Re: Submittal of Comments
Draft Order WQ 2020-XXXX-UST
In the Matter of the Petition of RCH Corporation
For Review of Denial of Petroleum Underground
Storage Tank Closure Case at
7891 Stockton Boulevard, Sacramento

**COMMENTS TO DRAFT WQ ORDER 2010-XXXX-UST
DENIAL OF PETROLEUM USTV CASE CLOSURE
AT 7891 STOCKTON BOULEVARD, SACRAMENTO
Presented by RJZ Associates**

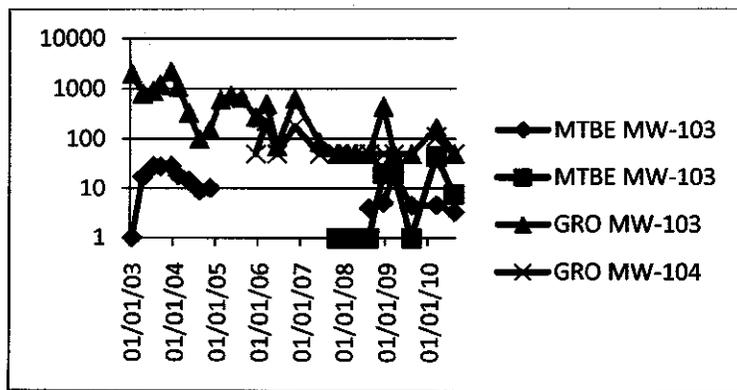
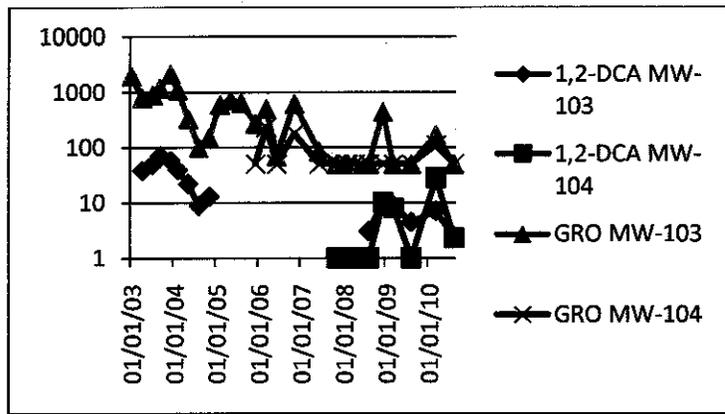
SB Comment - Concentrations of 1,2 dichloroethane (1,2 DCA), however, have primarily and consistently been reported in wells MW-103 and MW-104. The lack of 1,2 DCA in the other Site monitor wells, particularly in the wells located near the former/current USTs, suggest that there are two release areas at the Site.

The two graphs below show the historical data for wells MW-103 and MW-104 for gasoline range organics (GRO), 1,2-DCA and MTBE. The 50 ug/l flat line for TPHG is actually the detection limit, not an indication of an actual concentration at that level.

RP Response – This comment not actually correct. Referring to the graphs above, we note there was a spike in MW-3 in 2003 for 1,2-DCA and MTBE followed by a five year ND gap and then in 2009 another spike for 1,2-DCA and MTBE in MW-3 and the new MW-104. The GRO observed in 2003 shows the effect of natural attenuation throughout the entire record, but without the second spike. This appears to demonstrate the effect natural attenuation is having on the presence of GRO, 1,2-DCA and MTBE in the vicinity of wells MW-103 and MW-104.

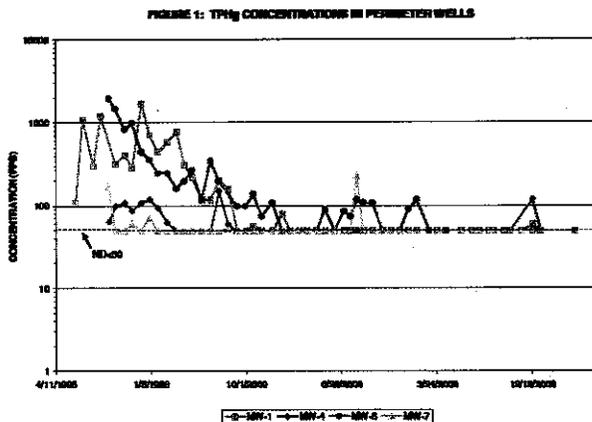
SB Comment - As the graph below depicts, there is a decreasing trend of TPHg concentrations in perimeter wells MW-1, MW-4, MW-5, and MW-7. This decreasing trend demonstrates that the remaining petroleum hydrocarbon mass is likely confined to soils in the central portion of the Site near the gasoline and diesel UST area and that the groundwater plume that is monitored by the existing well network is likely shrinking by natural attenuation (Figure 1).

RP Response – The significance of this comment appears to have been overlooked by the State Board petition reviewer. This comment seems to be saying the plume is stable and is likely shrinking. If this is the case, Resolution 92-49 logic should apply here. There are no nearby receptors and the site will meet water quality objectives within a reasonable amount of time. That looks like a low risk site closure.

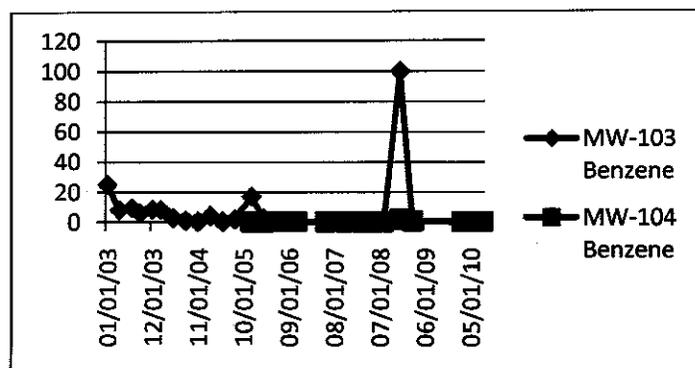
c. The Central Valley Water Board shall require the sampling of the domestic water supply wells within 1,000-foot radius of the Site for BTEX, MTBE and 1,2 DCA.

We have already discussed the 1,2-DCA and MTBE found in MW-103 and MW-104. The benzene concentrations graph below for MW-103 and MW-104 shows the historical record for these wells. It appears quite obvious that the benzene concentrations in the vicinity of these wells have naturally attenuated to acceptable levels, and if the levels are acceptable within fifty feet of the source area, then one can reasonably conclude they will be acceptable five hundred or more feet down gradient and side gradient. We cannot explain the 2009 hit in MW-103, but we are inclined to discount this reading, given the detection limit findings both before and after this sample event. If the 100 ug/l hit is real, it just shows the natural attenuation process is working.

Dhami Truck Plaza
 7891 Stockton Boulevard
 Sacramento, California
 Assessor's Parcel Address Key, 1000 ft Radius
 051112 March 12, 2010 Figure - 4

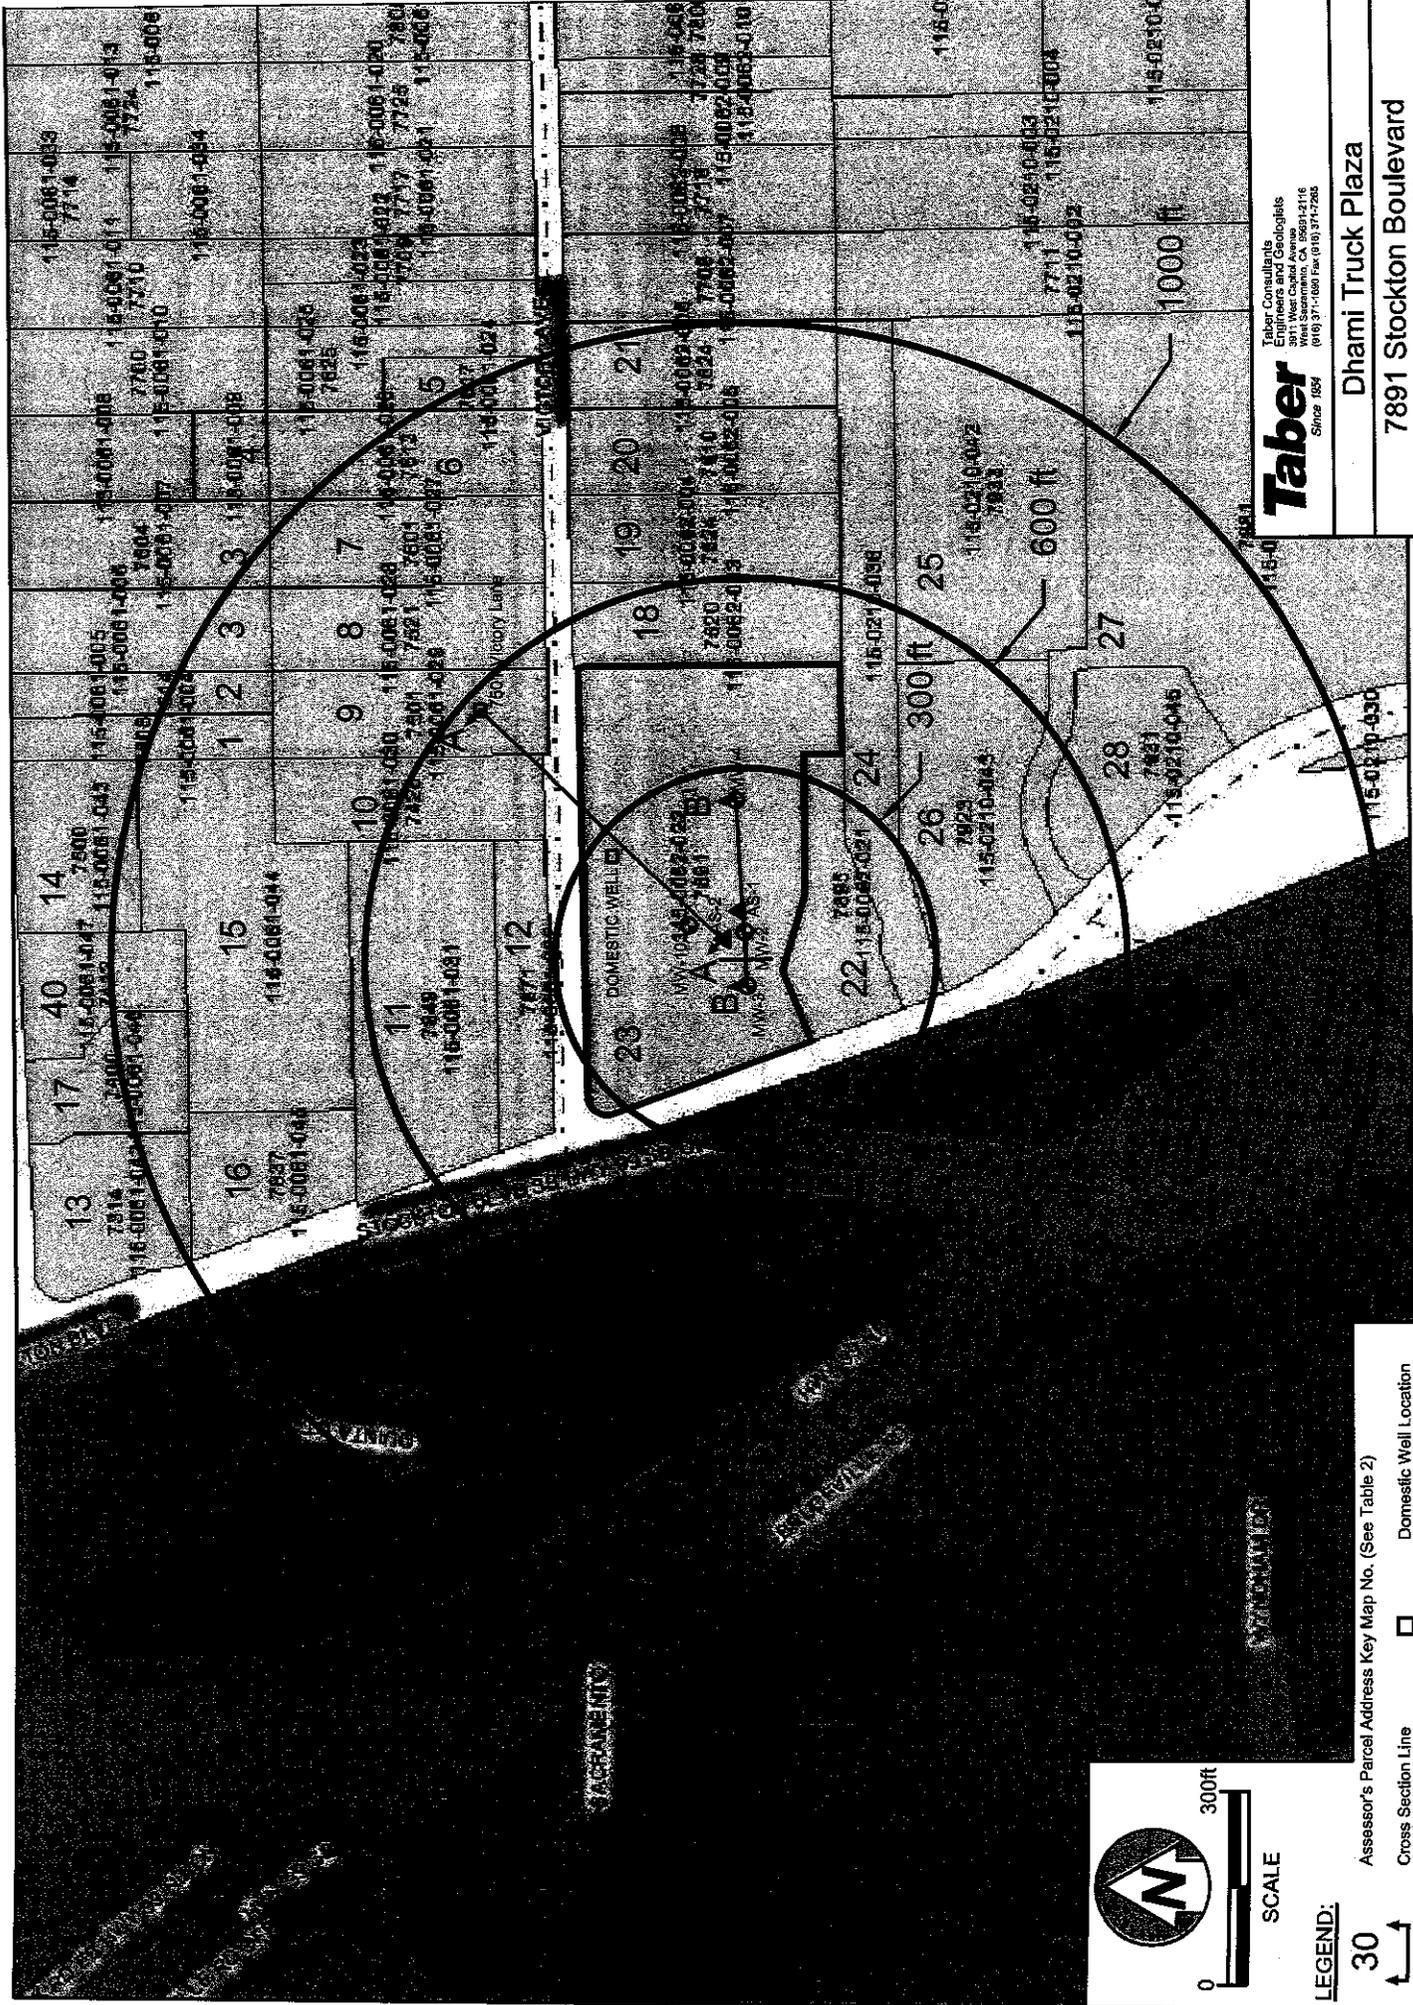
SB Comment - 3) Nearby domestic water supply wells have not been sampled for benzene, toluene, ethylbenzene, and xylenes (BTEX), MTBE and 1,2 DCA.

There are no domestic wells in the directly downgradient direction. The attached Figure 4 presents the Assessment Parcel map for the area and three radii of 300 feet, 600 feet and 1000 feet using the UST area as the center of the circles. Given the 15 feet/year estimated velocity the 300 foot radius represents 20 years of groundwater movement in the downgradient direction, the 600 foot radius about forty years, and the 1,000 foot radius about seventy years. Given the demonstrated natural attenuation within fifty feet of the UST area, it is difficult to envision particle movement much more than 100 feet from the source area.

RP Response – The above discussion appears to demonstrate any potential release from the UST area cannot possibly reach the nearest receptor (domestic well) located about 550 feet to the northeast. The groundwater gradient from the UST area to this well is essentially 0.00 feet/foot, resulting in zero flow in that direction, despite a theoretical anisotropic migration presented by Regional Board staff. Thus there is no need to sample wells as far away as the receptors are located. Natural attenuation processes are degrading any TPH constituents well within the property boundaries, and there is nothing suggesting this condition will change in the foreseeable future before groundwater meets water quality objectives at this site. The requested sampling does not appear to be a reasonable and cost effective use of USTCF resources, consistent with Water Code section 13267.
